400 Chestnut Street Tower II

In the Matter of the Application of) Docket Nos. 50-327
Tennessee Valley Authority) 50-328

Enclosed are responses to Reactor Systems Branch questions (items 212.104 through 212.114) on Loss of Coolant Accidents (LOCA) transmitted by your letter to H. G. Parris dated August 21, 1979. These responses will be incorporated into the Sequoyah Nuclear Plant Final Safety Analysis Report by Amendment 62.

RESPONSES TO REACTOR SYSTEMS BRANCH QUESTIONS

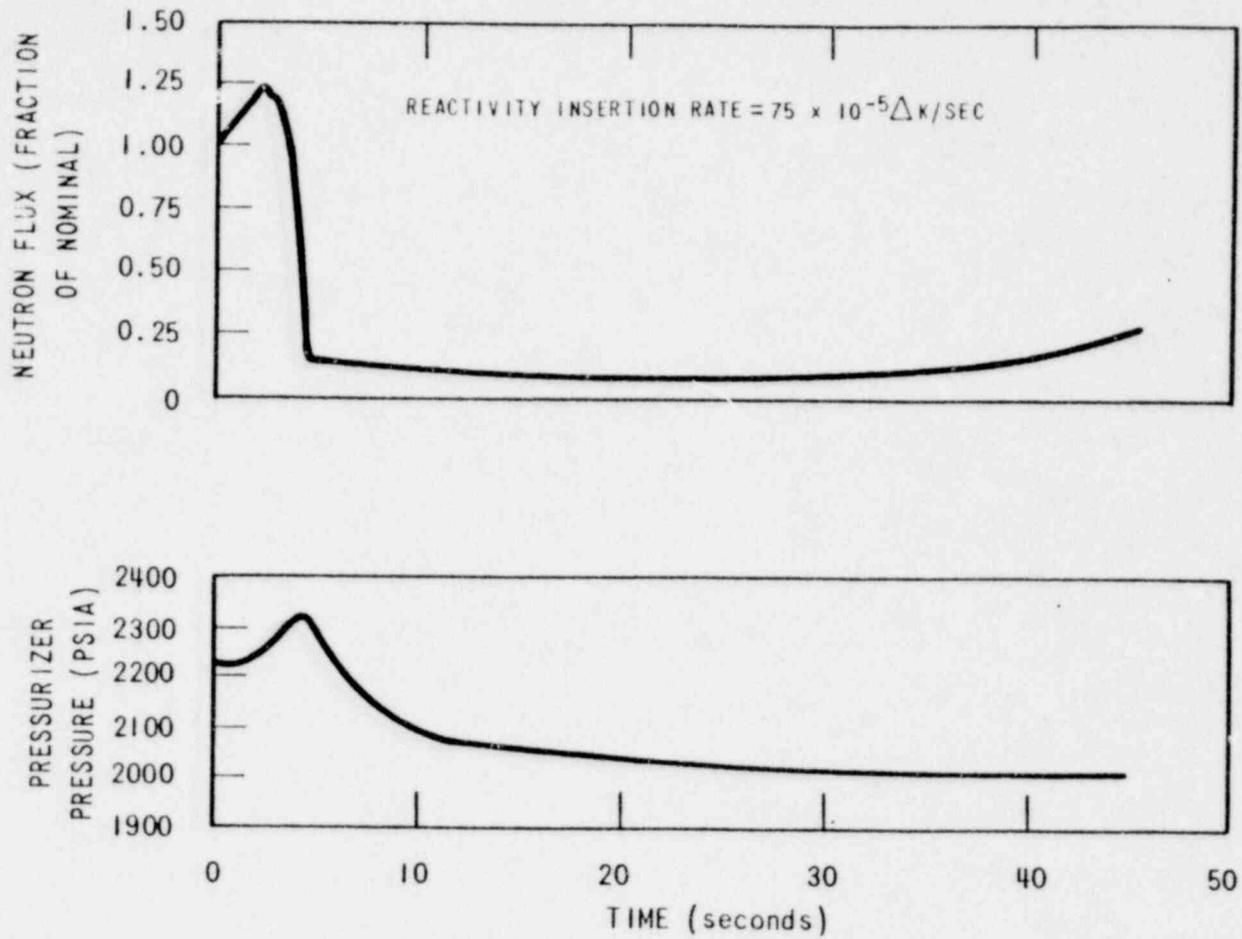
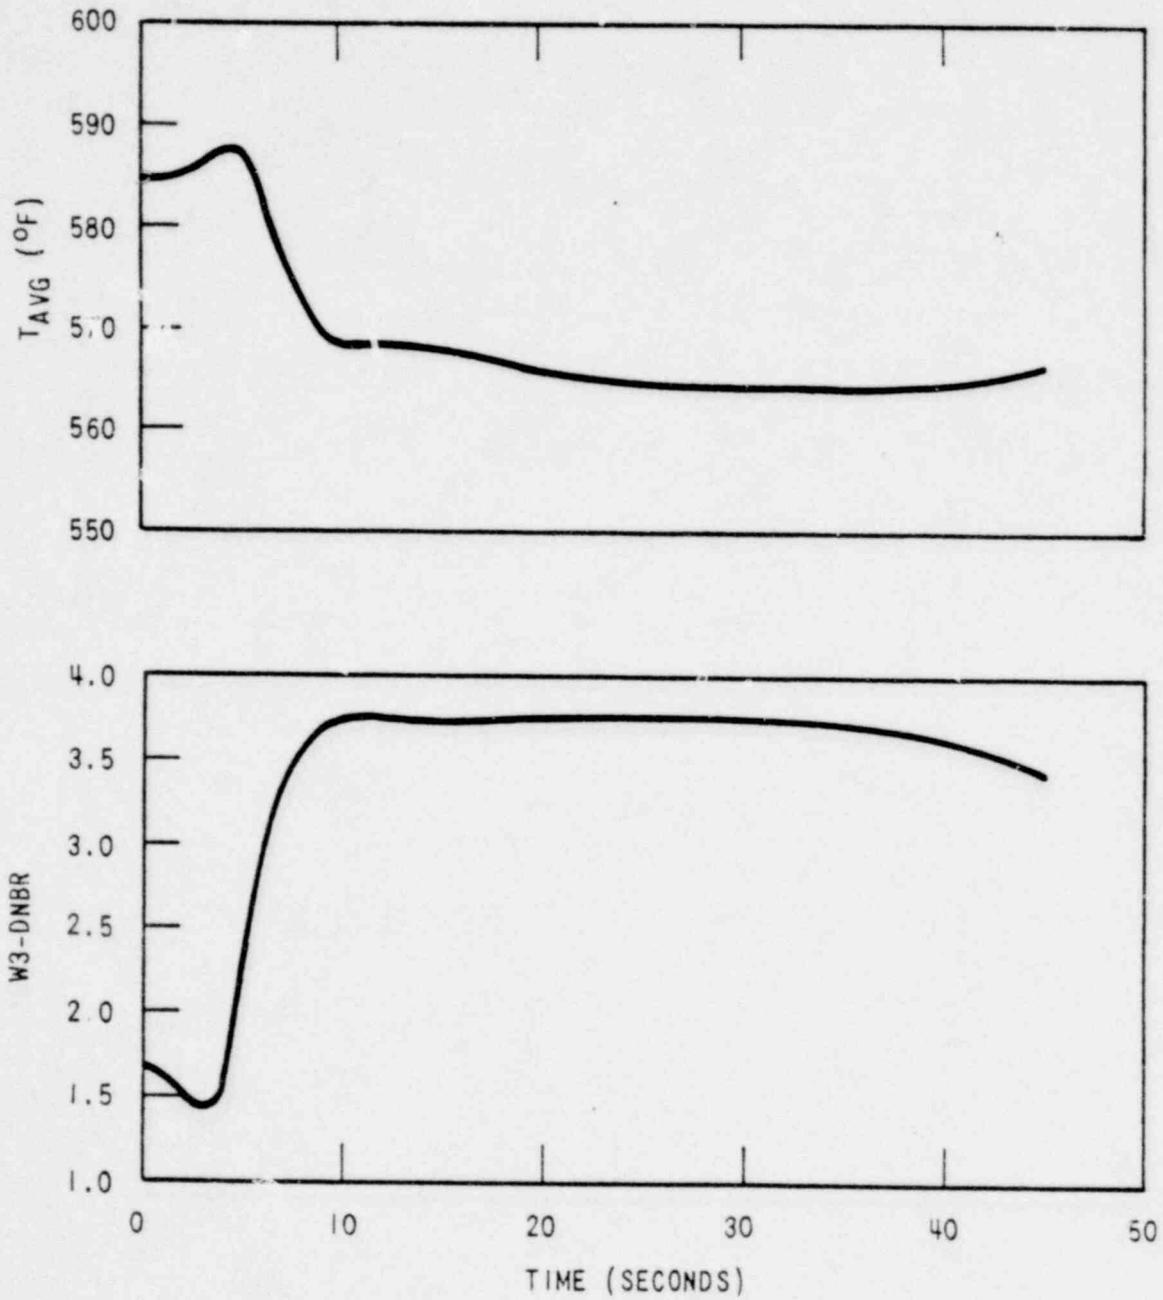
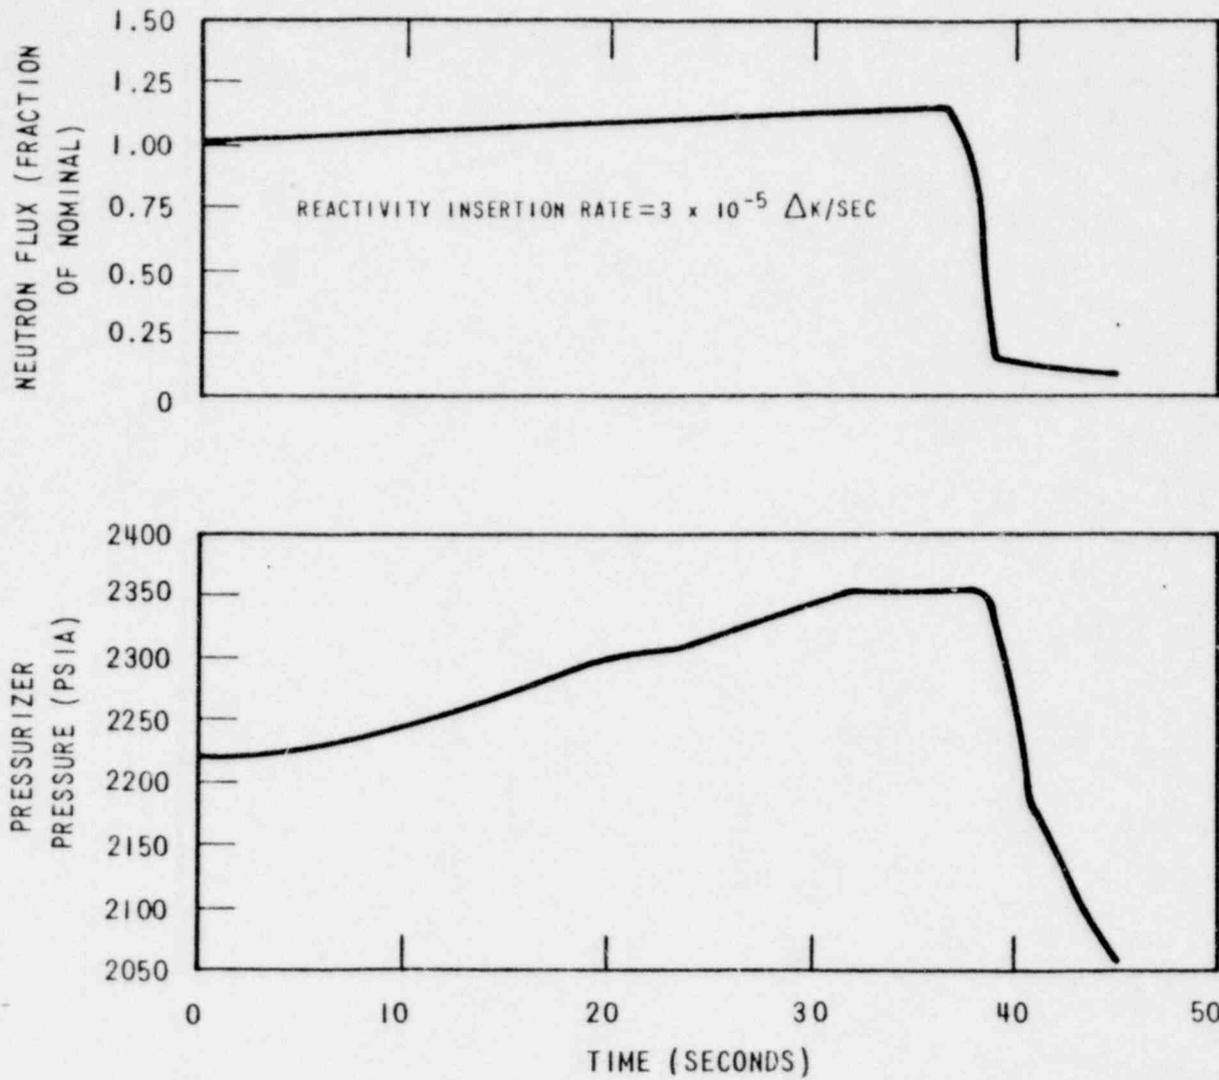
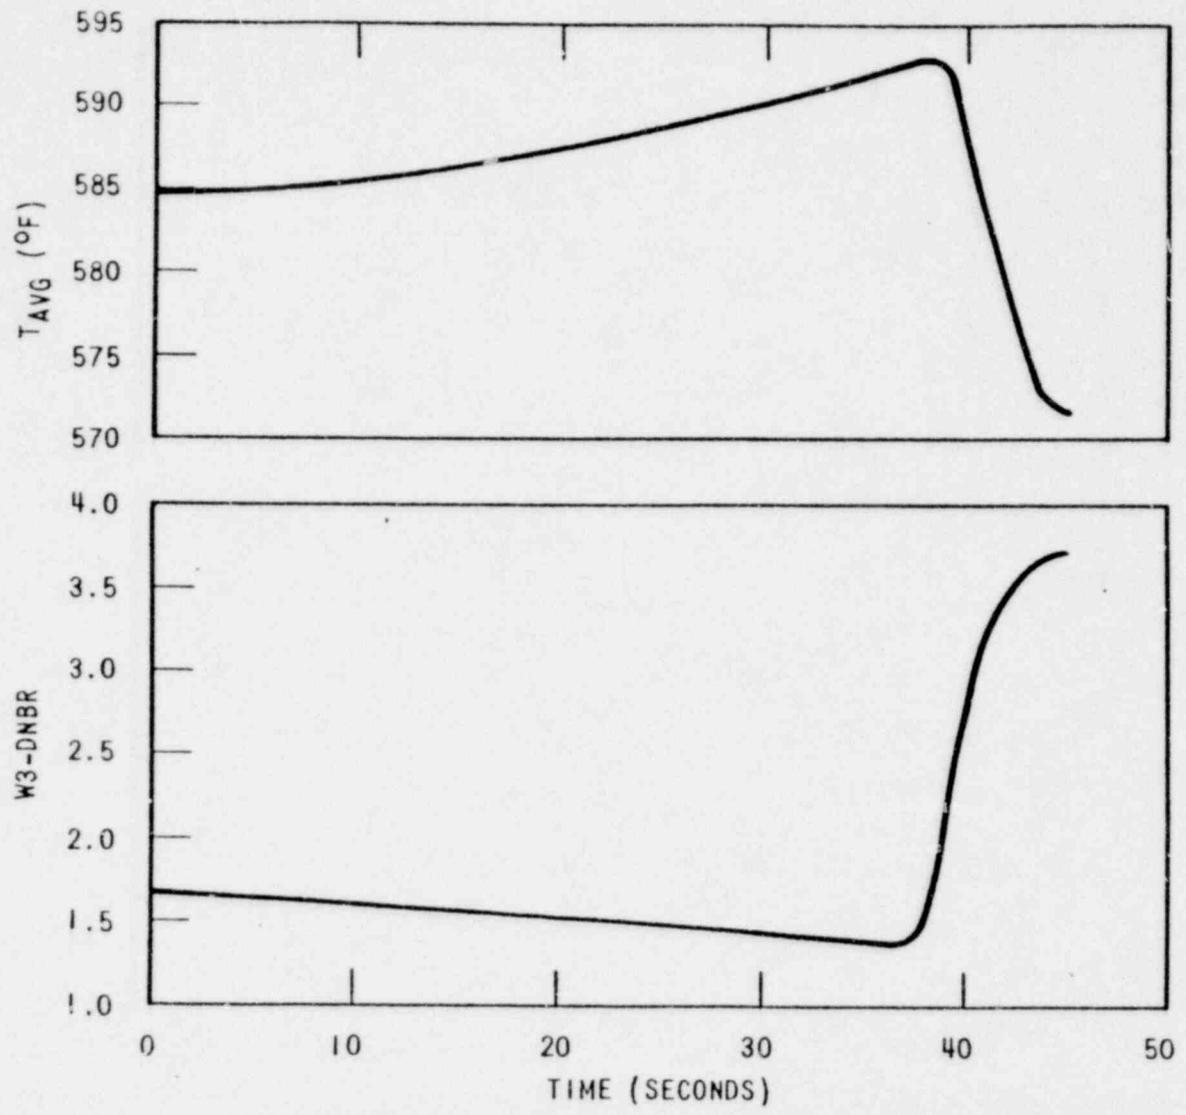
(212.106) The response to Q15.26 has discussed temperature measurement and modifications to Sequoyah reactor internals that would increase bypass flow to assure that 4 percent of the total cold leg flow would enter the upperhead region to maintain the upperhead region temperature at the cold leg value. The response has not addressed concerns about the impact of this increased bypass flow on Chapter 15 analyses. Please address this concern.

An increase in core bypass flow affects the overtemperature ΔT protection setpoint calculation. The appropriate setpoint and Tech Spec revisions have been made. The overtemperature ΔT trip is required for protection during transients which approach DNB. This trip is most important during the slow rod withdrawal at power event.

The rod withdrawal at power accident has therefore been reanalyzed, using the adjusted overtemperature ΔT setpoints. The conclusions drawn in the FSAR are unchanged for this new analysis (i.e. the DNBR does not fall below 1.30). Appropriate revisions have been made to Section 15.2 to reflect this new analysis.
